NEW TERRITORIES MASTER PLAN

PRELIMINARY OVERALL AREA DEVELOPMENT PLAN

RE: New Territories POADP #187

RE: New Territories P.O.A.D.P. (Revised August 26, 1985)
(File #83-10-61-60)

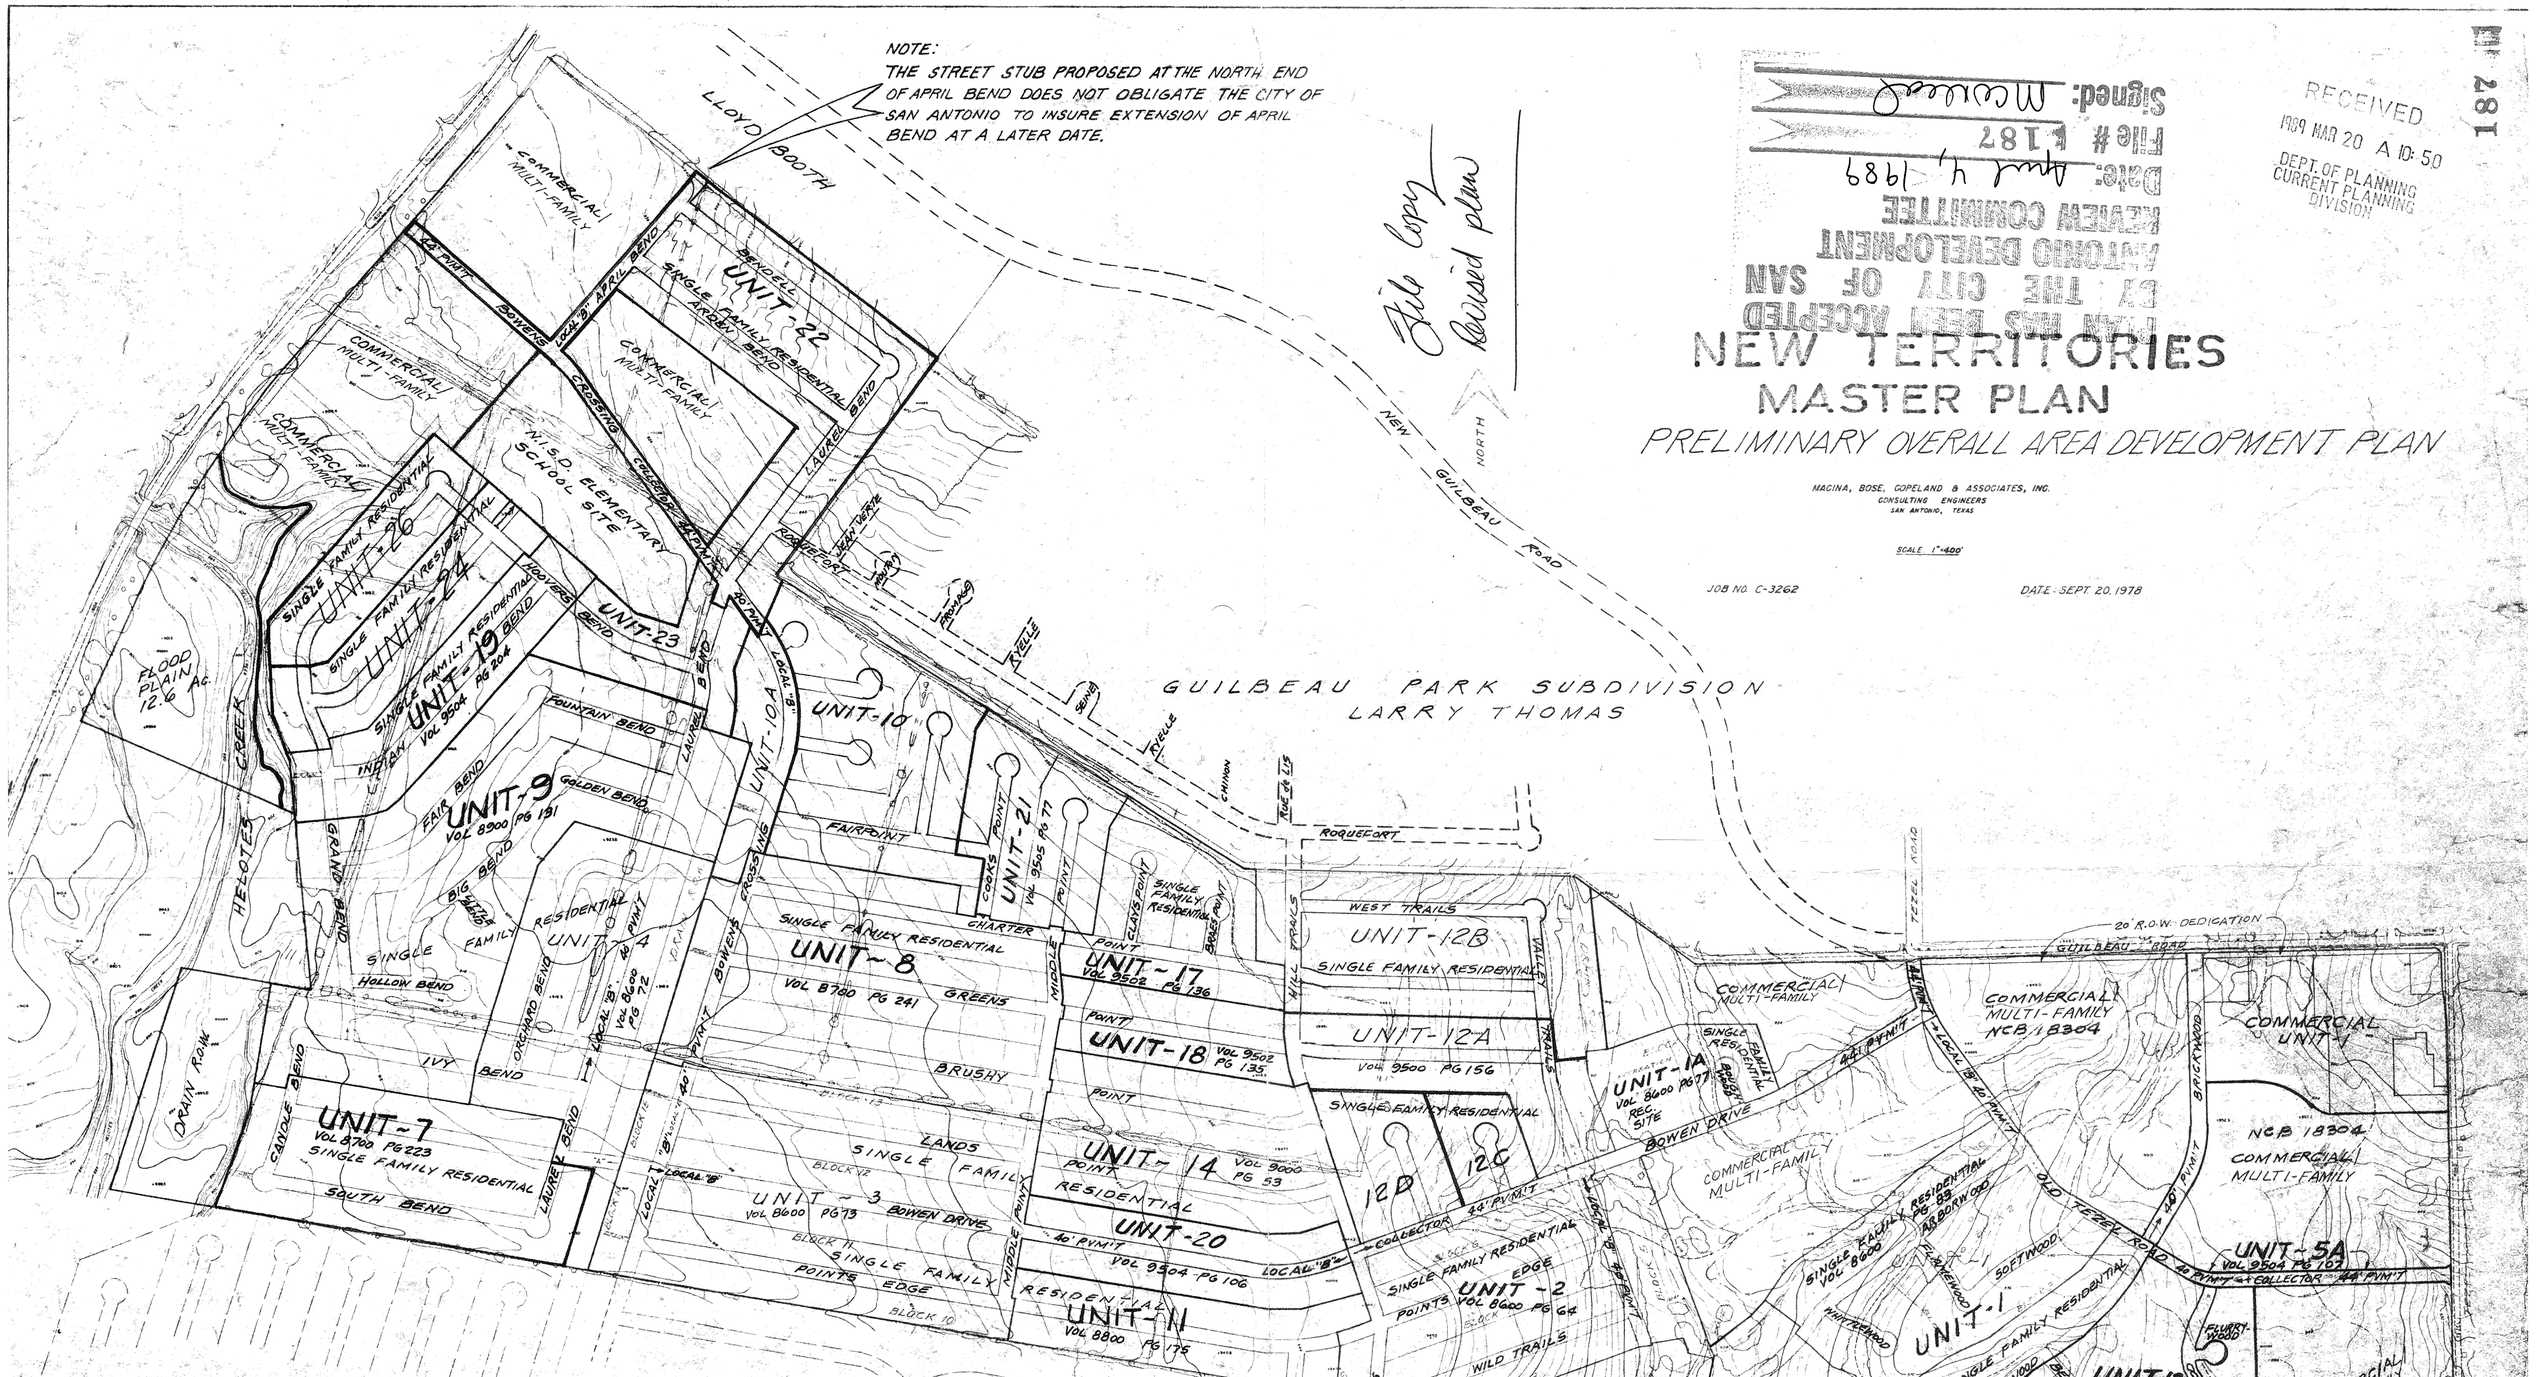
It is noted that the removal of April Bend Drive leaves an undesirable stub street in New Territories Subdivision Unit-24. Staff recommends that if the stub street has not been constructed, the stub street be removed and designated as an easement. Please coordinate this effort with the Traffic and Transportation Section of the Department of Public Works.

The Development Review Committee has reviewed and accepted your proposed plan for New Territories. The plan has been assigned File #187 for future reference.

NEW TERRITORIES
MASTER PLAN
PRELIMINARY OVERALL AREA DEVELOPMENT PLAN

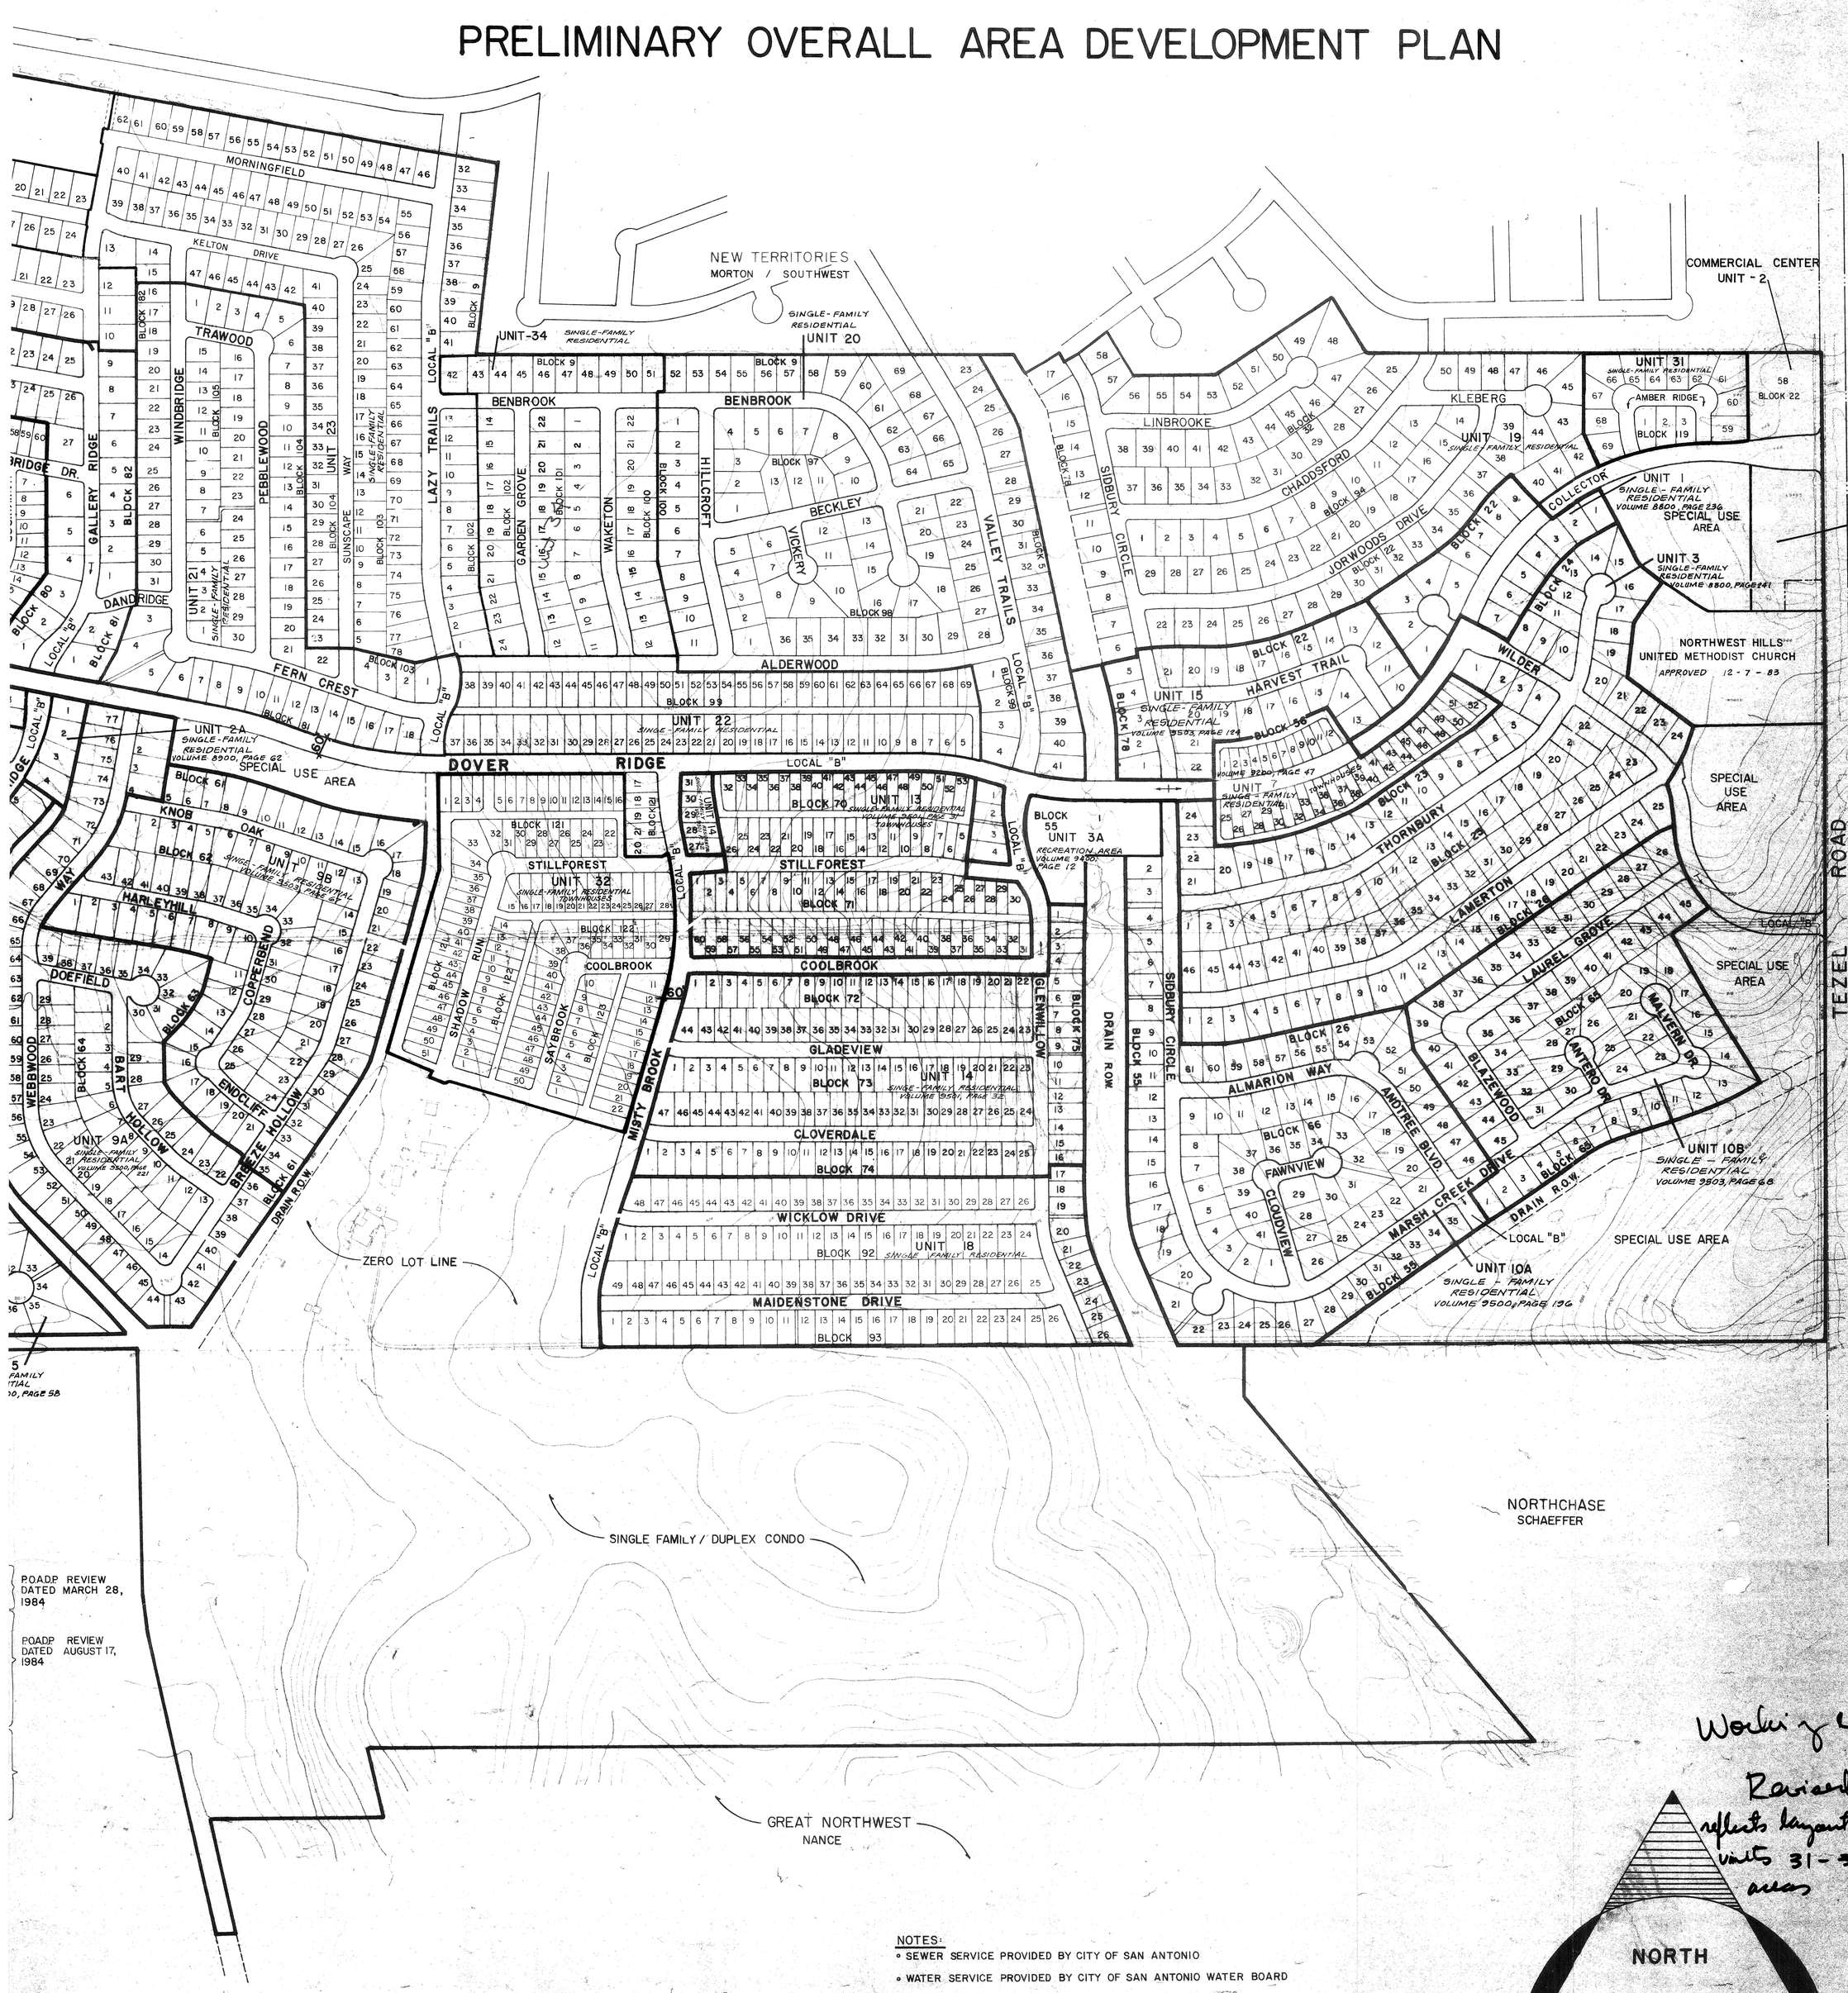
Working copy
Revised Plan reflects layout for proposed units 31-34 high-density areas
